**Re: Approval of the Final Plat of Valley View Farms, a proposed 31 lot residential subdivision in SW $\frac{1}{4}$  of the SW $\frac{1}{4}$  of Section 30 of Butler Township.**

STAFF REPORT

**Request:** Final Plat of Valley View Farms

CHK BY: BCH	APV BY: DJK
XCEL JOB NUMBER: 171140	
DRAWING NUMBER: 1 OF 2

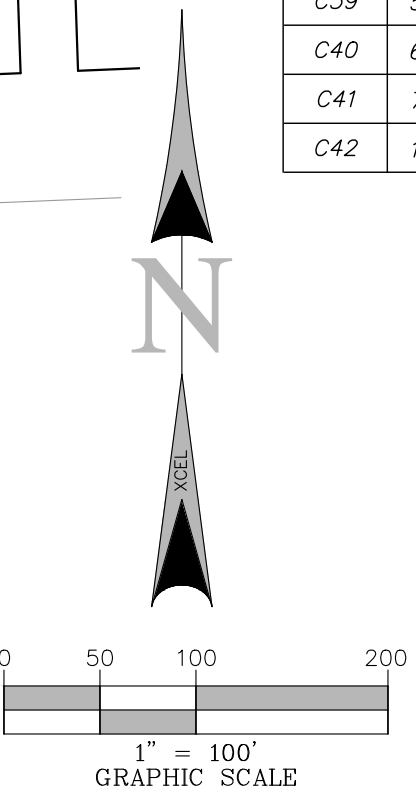
All of these conditions of approval recommended by the Planning Commission have been met prior to this Final Plat being placed on the Board's agenda. However the issue of whether these subdivision roads will be accepted by the County remains unresolved and was not addressed by the Planning Commission.

Whether Scott County is going to accept roads on to the County Secondary Roads system is not an issue normally addressed by the Planning Commission. Currently the Restrictive Covenants that were submitted with this plat call out for the roads to be dedicated to Scott County with the understanding that they would then be maintained by the County. Historically this has been an issue addressed by the County Board and the County Engineer after a plat is approved. The Subdivision Regulations state that all road construction plans must be reviewed and approved by the County Engineer prior to construction and the County Engineer is to inspect those roads during construction to ensure compliance with County road standards and the approved construction plans. The Subdivision Regulations provide that the County Engineer may do the inspections with County inspectors or hire an outside firm and bill the developer for those costs. Regardless of how the roads will be maintained the requirement is that they be built to County standards. The Subdivision Regulations provide for the decision on road maintenance be addressed by the Board of Supervisors with a recommendation by the County Engineer after the Final Plat is approved and recorded.

In this case the County Engineer has indicated from the time this plat was submitted that he would not be recommending that the roads be accepted onto the Secondary Roads system. Therefore, if the Board determines it will not approve the acceptance of these subdivision roads, the proposed covenants will need to be amended to reflect that and provide that the Homeowners Association be given the responsibility for maintaining these roads and that the roads remain private. If that is the case, any resolution approved by the Board should include the requirement for private road maintenance be included in the Private Covenants as a condition of Board approval.
